HISTORIC AND DESIGN REVIEW COMMISSION

HDRC CASE NO: 2023-304
ADDRESS: 1009 W ROSEWOOD AVE
LEGAL DESCRIPTION: NCB 3109 BLK 8 LOT 5 & 6
ZONING: R-6, H
CITY COUNCIL DIST.: 1
DISTRICT: Public Property
APPLICANT: Alma Nunez | City of San Antonio
OWNER: City of San Antonio
TYPE OF WORK: Dog park construction
APPLICATION RECEIVED: July 24, 2023
60-DAY REVIEW: September 22, 2023
CASE MANAGER: Bryan Morales

The applicant is requesting a Certificate of Appropriateness for approval to convert the existing park into a dog park.

BEACON HILL LINEAR PARK IMPROVEMENTS DOG PARK

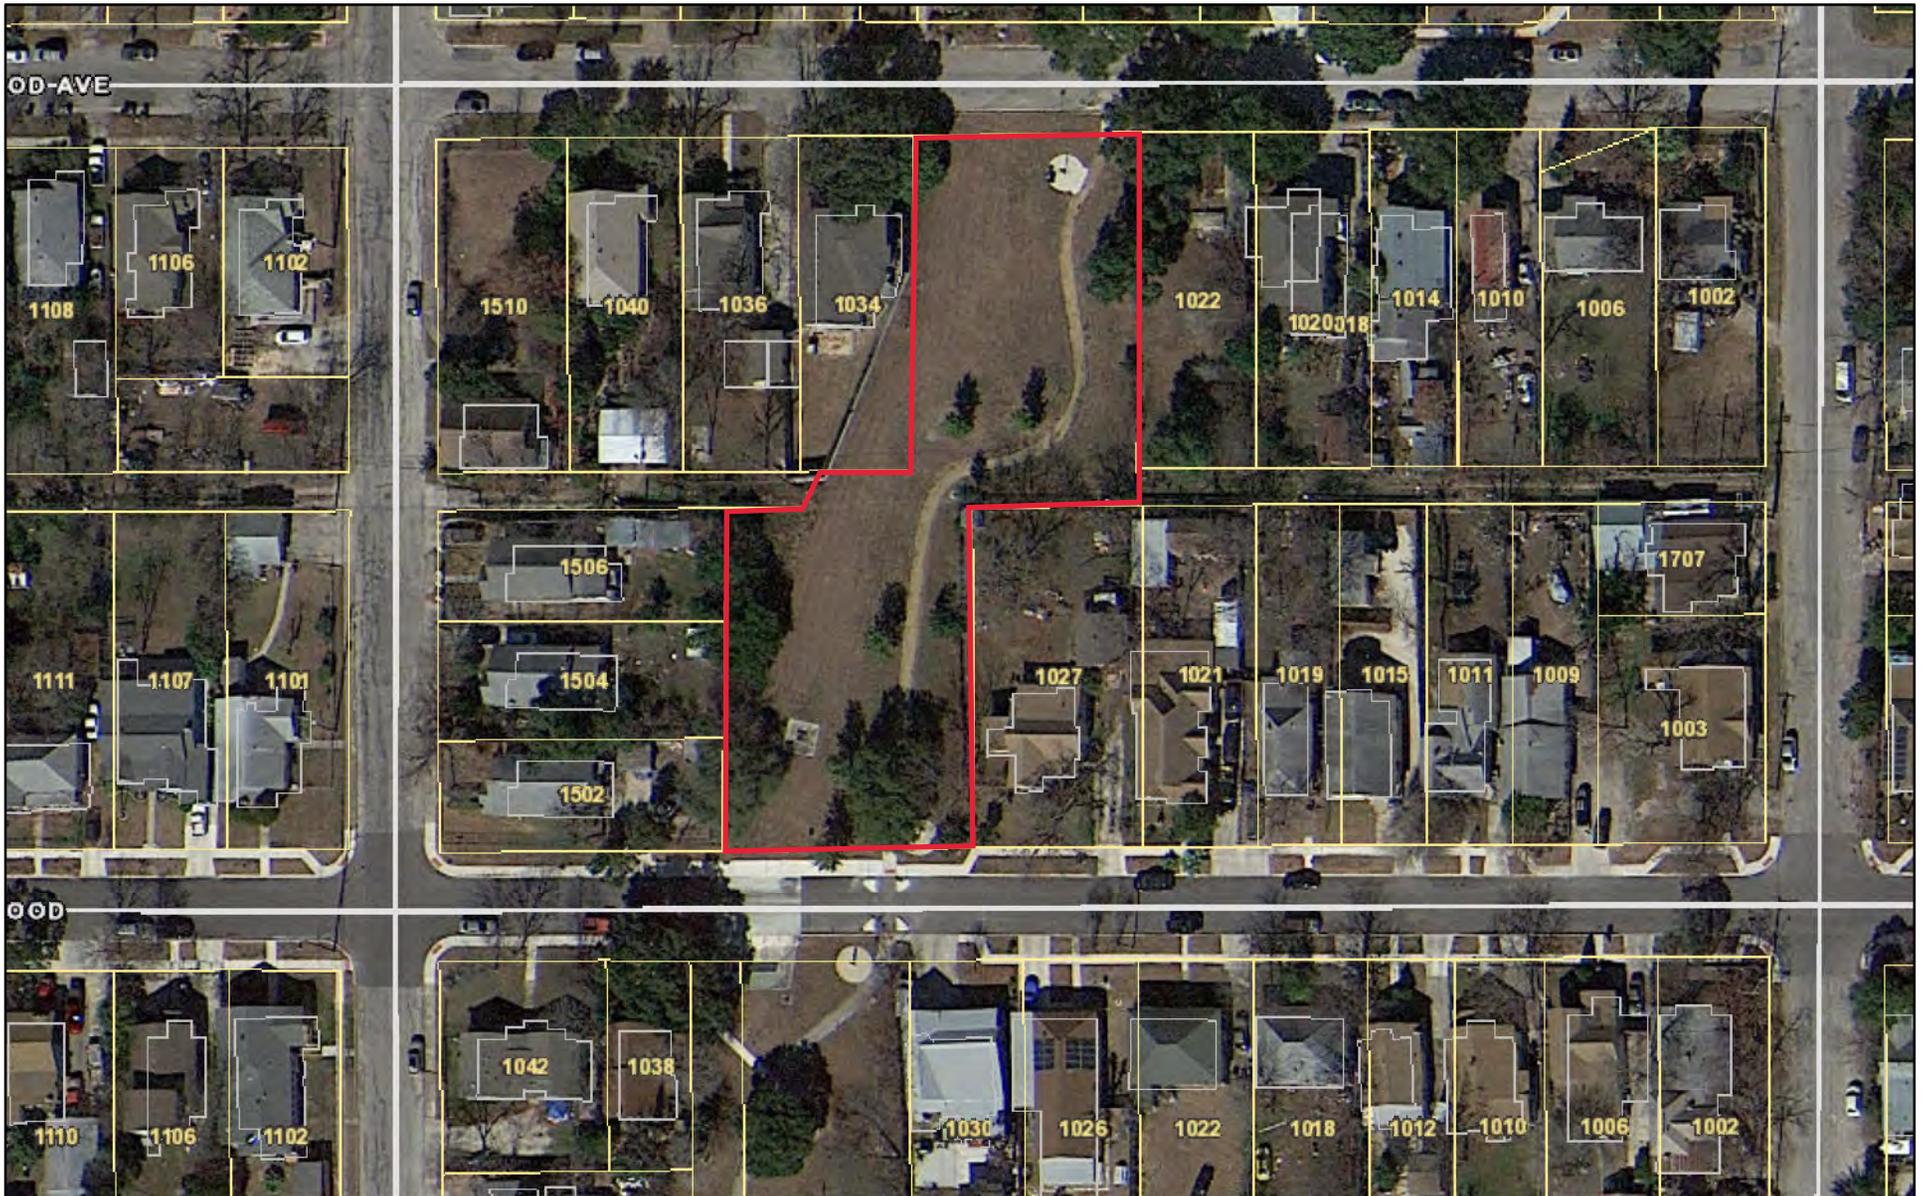
- a. The park located at 1009 Rosewood between Rosewood Ave and W Lynwood Ave is approximately .77 acres and features a decomposed granite walking trail, several trees, and a concrete storm water drain.
- b. TRAIL MODIFICATIONS – The applicant is requesting to remove the existing decomposed granite trail and relocate it to run alongside the eastern border of the park. The Historic Design Guidelines for Site Elements 5.A.iii. states to

follow the historic alignment, configuration, and width of sidewalks and walkways. Staff finds the request generally appropriate.

- c. **FENCE AND GATE INSTALLATION** – The applicant is requesting to install a six feet tall black metal architectural panel fence along the perimeter of the property and through the middle. Additionally, the applicant is requesting to install two gates of the same characteristics of the proposed fence for access to each fenced section. Guidelines for Site Elements 2.B.iii. states to limit the height of new fences and walls within the front of the property to four feet. Site Elements 2.B.v. states to select materials that are similar in scale, texture, color, and form as those historically used in the district and that the review of alternative fence heights and materials for appropriateness where residential properties are adjacent to commercial or other potentially incompatible uses. Staff finds the installation of the fence and two gates are generally appropriate.

- d. **HARDSCAPE INSTALLATION** – The applicant is requesting to install approximately 1,484 square feet of concrete on the section closest to W Lynwood Ave. Guidelines for Site Elements 3.B.i. states to not introduce large pavers, asphalt, or other impervious surfaces where they were not historically located. Staff finds the installation of approximately 1,484 square feet of concrete is generally appropriate.

Staff recommends approval of the request, based on findings a through d, with the following stipulation:

- i. That the applicant meet all setback standards as required by city zoning requirements and obtain a variance from the Board of Adjustment if applicable.
